Access Compliance Report Public Rights-of-Way (Curb Ramps)

Main Street: ROSSMOOR_CENTER_WAY		Cross Street: N/A		Location:	SE
ADA ID: RPRK211208120442	Ramp Type: Type 1 - Perpendicular	Initial Pass/Fail: Fail	Overall Compliance: No	Severity Score:	15
Codes/Mitigation Info/Possible Solution			Field Measurements/Component Compliance

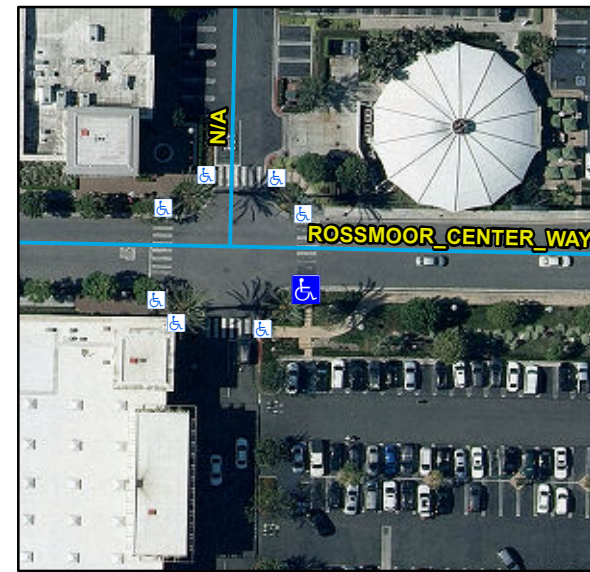
Compliance	Description	Data	Compliance	Description	Data
N/A	Ramp Length (in)	84	N/A	Flare Type LT	
Yes	Ramp Width (in)	72			N/A
No	Ramp Run Slope (%)	10.7	N/A	Flare Slope LT (%)	N/A
Yes	Ramp Cross Slope (%)	1.8	N/A	Flare Traversable LT	N/A
N/A	Landing Present	N/A	N/A	Flare Type RT	
N/A	Landing Length (in)	N/A			N/A
N/A	Landing Width (in)	N/A	N/A	Flare Slope RT (%)	N/A
N/A	Landing Run Slope (%)	N/A	N/A	Flare Traversable RT	N/A
N/A	Landing Cross Slope (%)	N/A	N/A	DWS Provided	N/A
N/A	Landing Movement Obstructed?	N/A	N/A	DWS Contrast	N/A
	Landing Movement Type	N/A	N/A	DWS Length (in)	N/A
N/A	Landing Shared	N/A	N/A	DWS Full Width	N/A
N/A	Clear Space	N/A	N/A	DWS Offset Left (in)	N/A
N/A	Clear Space To Crosswalk (in)	N/A	N/A	DWS Offset Right (in)	N/A
N/A	Marked Crosswalk 1	Yes	N/A	Marked Crosswalk 2	N/A
	Crossing 1 Direction	N		Crossing 2 Direction	N/A
	Marked Crosswalk 1 Width (in)	144		Marked Crosswalk 2 Width (in)	N/A

Remove & Replace Entire Ramp.

R304.2.2, STD 1115
